Midway City Council
1 September 2020
Regular Meeting

Midway Vistas Subdivision,
Phase 1 /
Preliminary Approval

CITY COUNCIL MEETING STAFF REPORT

Subject: Midway Vistas Subdivision – Phase 1 Preliminary Review

KIRK MALMROSE
 MIDWAY VISTAS
 PRELIMINARY WATER PLAN

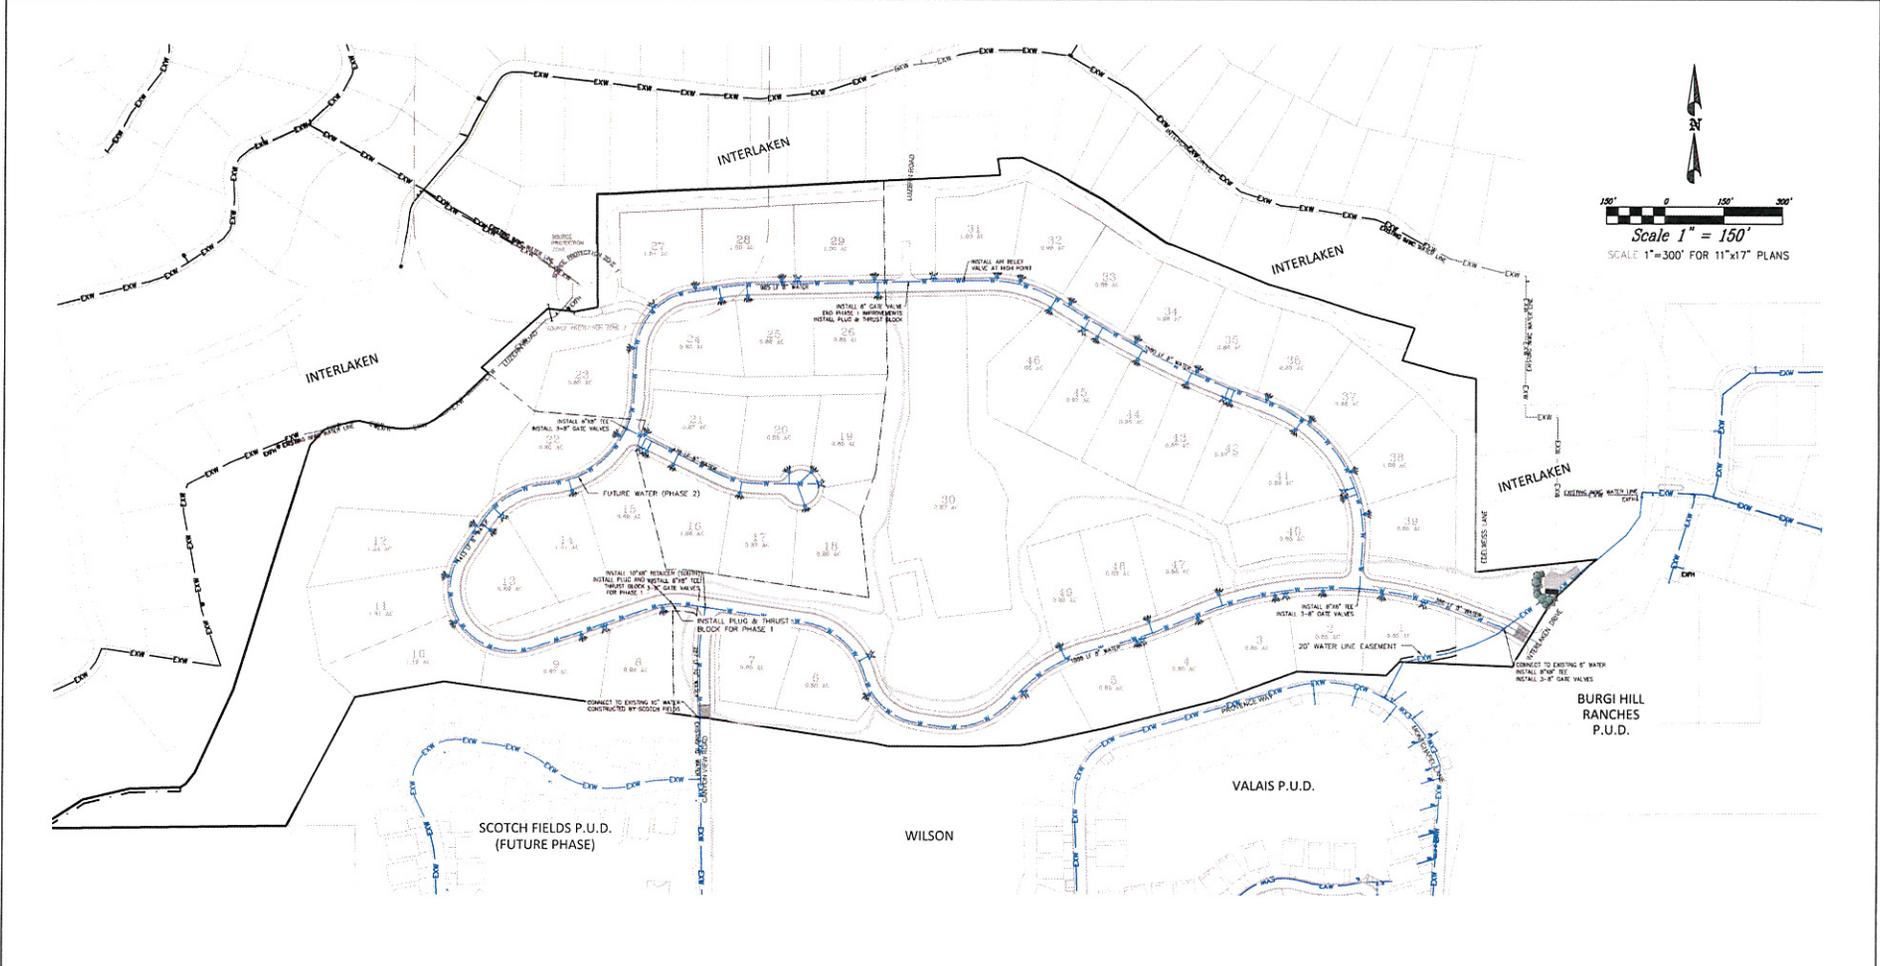
- The proposed development will be served from the Cottages on the Green pressure zone.
- The proposed development will connect to the existing 8" culinary water line near Interlaken Drive to the east of the subdivision and to a 10" culinary water line within Scotch Fields subdivision to the South of the proposed subdivision.
- Required water pressure and fire flows need to be addressed for lots higher in elevation.

KIRK MALMROSE
 MIDWAY VISTAS
 PRELIMINARY PRESSURIZED
 IRRIGATION PLAN

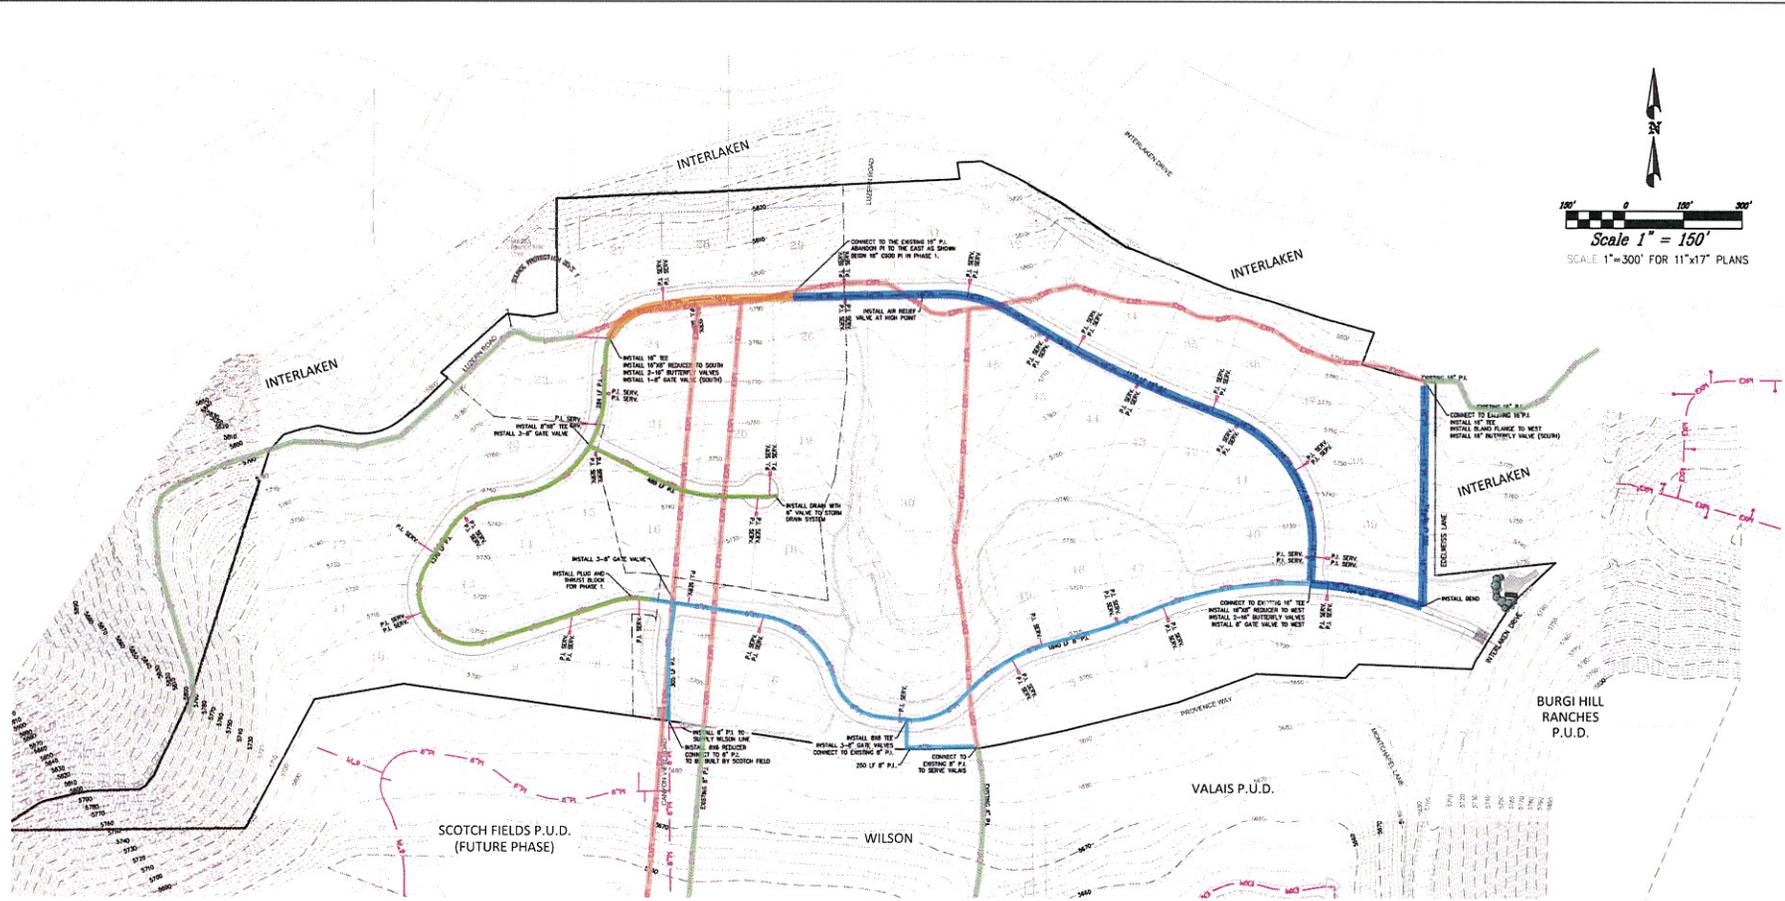
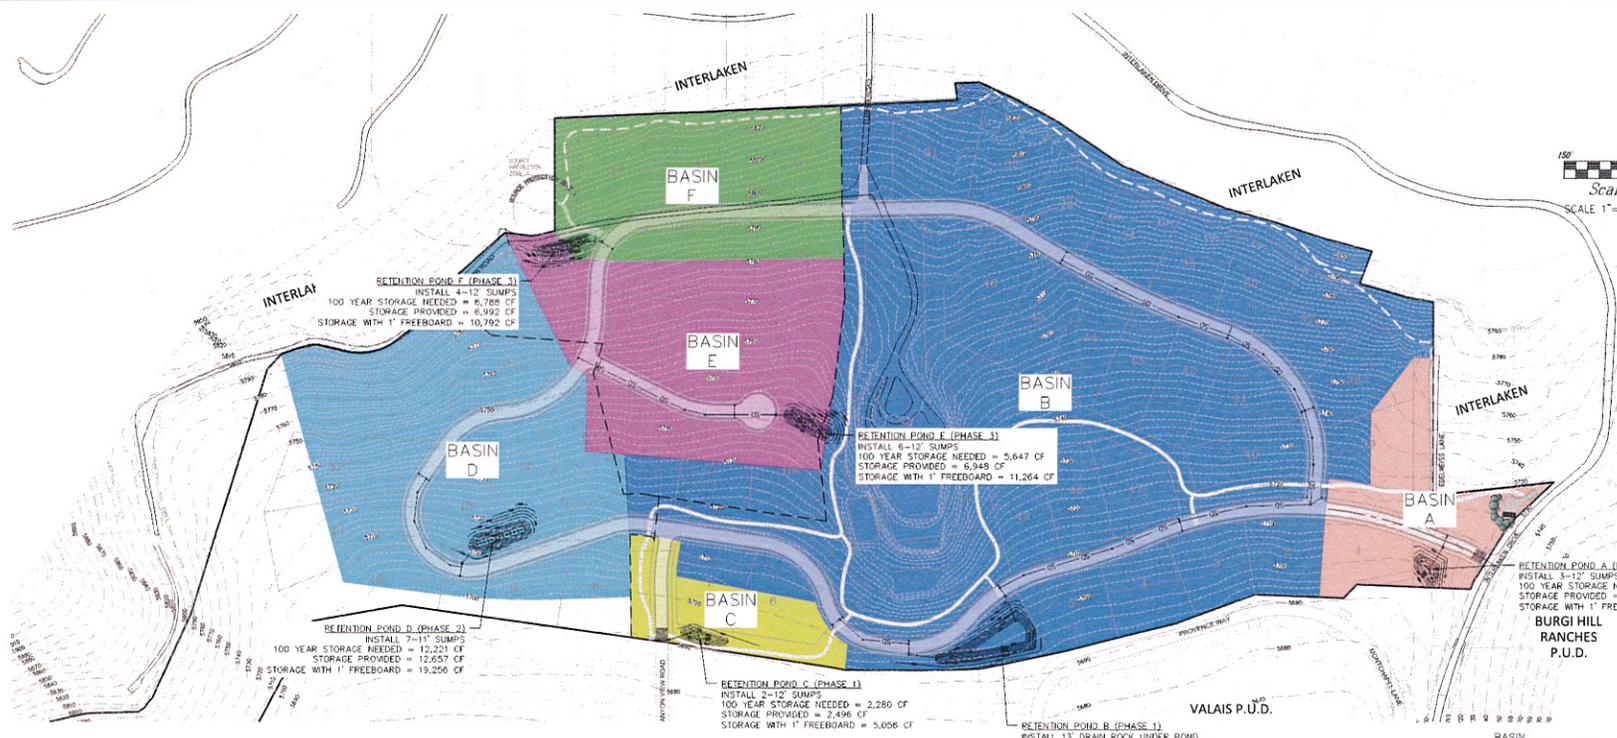
- The subdivision will be serviced by Midway Irrigation Company. Lots higher in elevation will likely have issues with low pressure. The use of ponds to assist in regulating pressures should be evaluated.
- All removal, additions, or revisions to pressure irrigation system must be approved by Midway Irrigation Company.
